HISTORIC AND DESIGN REVIEW COMMISSION

June 03, 2015

Agenda Item No: 29

HDRC CASE NO: 2015-215
ADDRESS: 623 E COMMERCE ST
LEGAL DESCRIPTION: NCB 151 BLK 1 LOT 1 (ST JOSEPH'S CHURCH) 2014-NEW ACCT PER SPLIT PER PLAT 9657/163-165 FILED 8/2/2013
ZONING: D H HE RIO-3
CITY COUNCIL DIST.: 1
DISTRICT: Alamo Plaza Historic District
LANDMARK: St Joseph's Catholic Church
APPLICANT: Mario Marzocchi
OWNER: Roman Catholic Archdiocese of San Antonio
TYPE OF WORK: New construction
REQUEST:

SITE PLAN
SCALE: 1:30

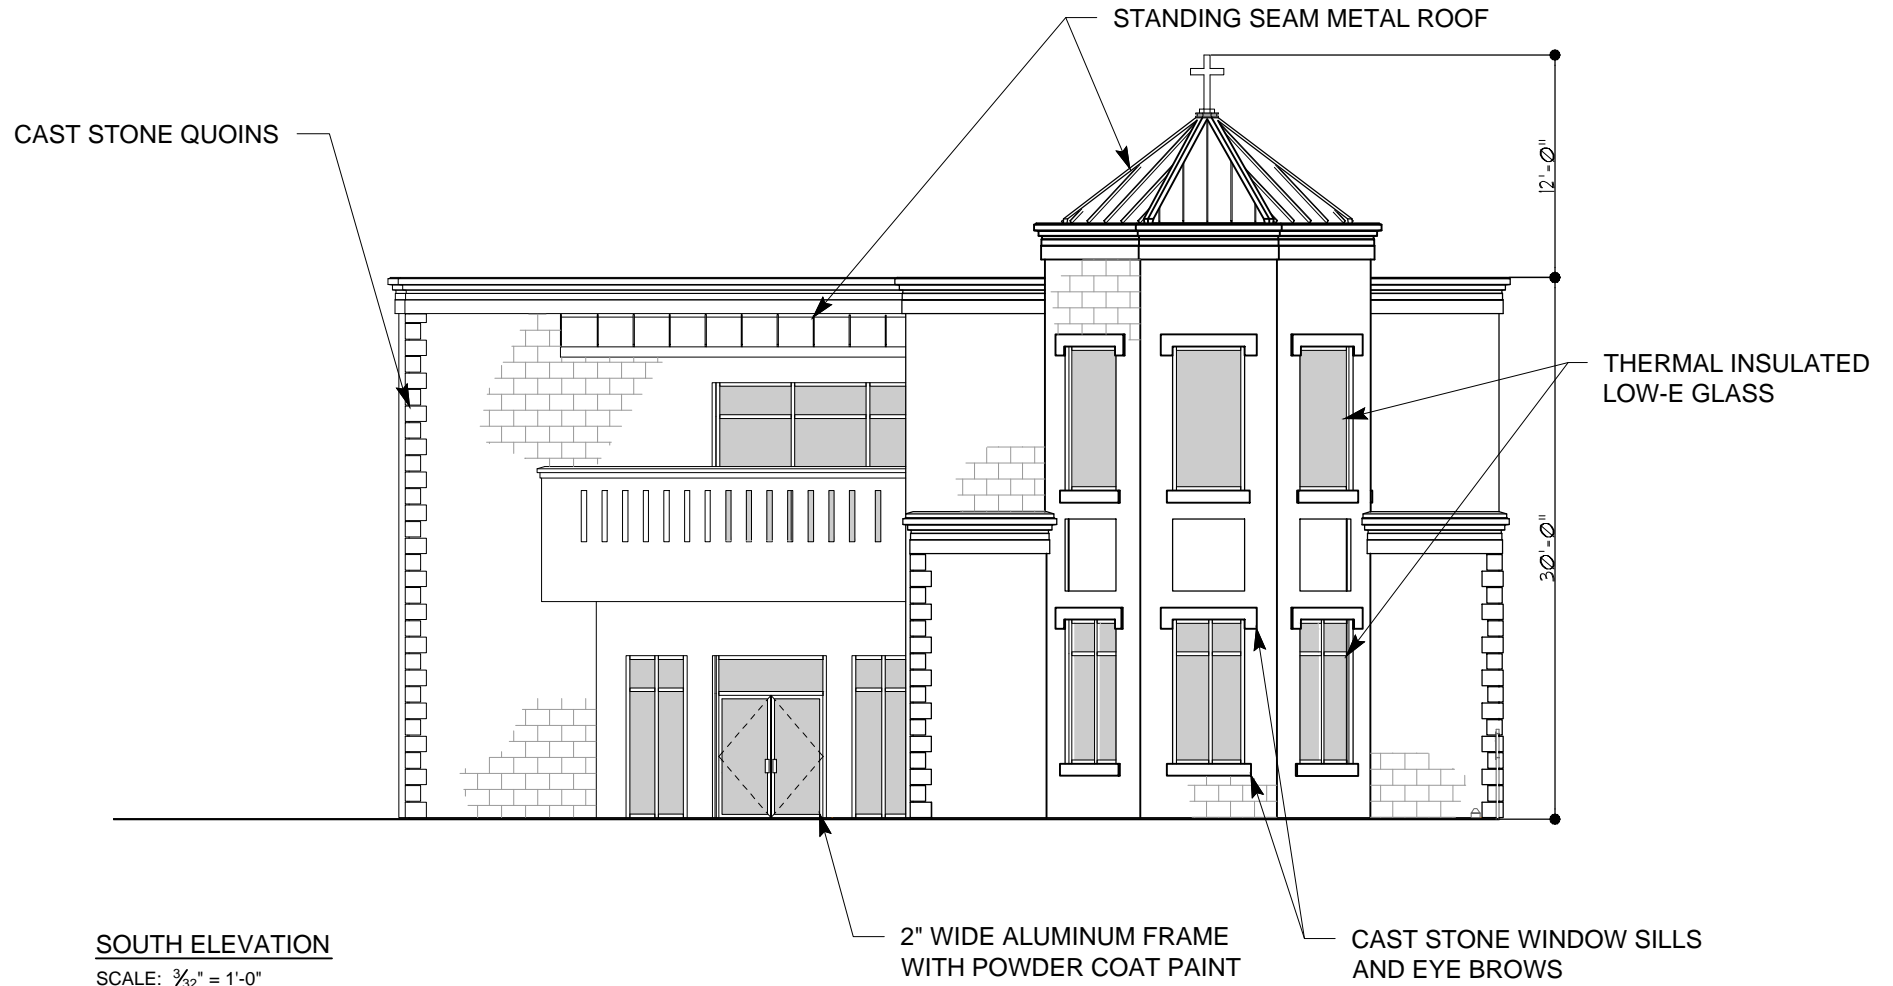
- a. The applicant has proposed to construct the new structure at the north east corner of the site, which is to the side and rear of the existing, historic structure. The proposed new construction is to be set back 65' from E Commerce and is to be oriented toward E Commerce. Staff finds that the proposed setback is appropriate and that the proposed building orientation is consistent with the Guidelines for New Construction 1.A.ii.

- h. The applicant has proposed to remove a portion of the existing asphalt parking lot and to replace it with a brick plaza that will extend from the proposed new structure to the side and rear of the existing Rectory and terminate at the side of the existing church. Staff recommends that the applicant provide more information regarding this proposed brick plaza including information regarding landscaping materials and the incorporation of plantings.

- i. The applicant has proposed to reconfigure the existing asphalt driveway which currently accommodates parking for approximately 15 vehicles. The applicant has proposed for the new, reconfigured asphalt parking lot to contain parking for 5 vehicles, including one handicapped parking space. Through this reconfiguration, the amount of asphalt on the site would be slightly reduced. This is consistent with the Guidelines, however the applicant should introduce a screening elements to screen the existing/proposed parking from the public right of way along E Commerce. The applicant should refer to the Guidelines for Site Elements, 7.B. regarding off street parking.

- i. That the applicant remove the proposed cast stone quoins from the proposed new construction.
- ii. That the applicant inset each aluminum window at least two to three inches within the exterior walls.
- iii. That the applicant buffer the existing/proposed parking from the public right of way along E Commerce.
- iv. Archaeological investigations shall be required for the project area.

SOUTH ELEVATION

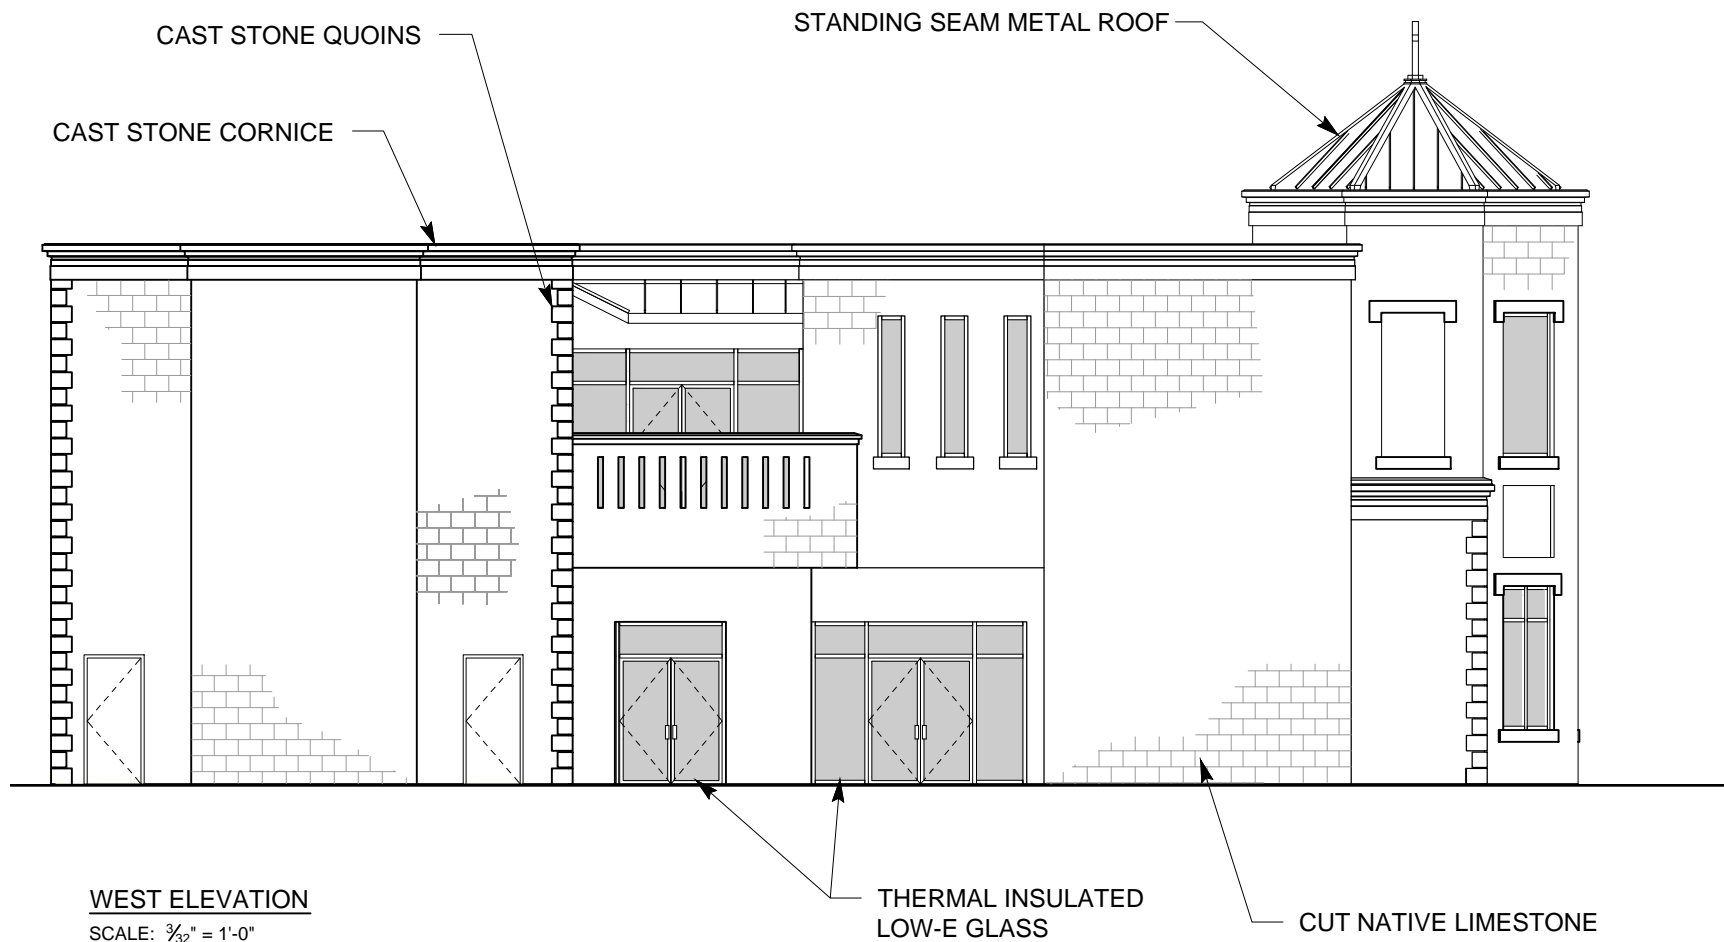
- b. According to the Guidelines for New Construction 2.A., new construction should feature a height and scale that are consistent with those of nearby historic buildings. The applicant has proposed for the overall height of the proposed new construction to be approximately 42' tall and feature similar floor heights as the neighboring structures. This is consistent with the Guidelines.

- d. In regards to windows and doors, the applicant has proposed window and door openings that are consistent in size with those of the existing structures on the site, however, the applicant has proposed for the new structure to feature aluminum framed windows. While aluminum framed windows would create a visual indication of the structure's new age, staff finds that more depth should be given to the façade through the use of these windows to prevent a "storefront" appearance. Staff recommends that the applicant inset each aluminum window at least two to three inches within the exterior walls.

- e. The applicant has proposed complementary materials such as cut native limestone, cast stone window sills and eyebrows, cast stone cornices and a standing seam metal roof. Each of these proposed materials either match those of the existing church or Rectory. These proposed materials are consistent with Guidelines for New Construction 3.A. The applicant has also proposed the use of cast stone quoins. Staff finds that this element creates a false sense of history and recommends that the applicant remove those from the proposed structure.
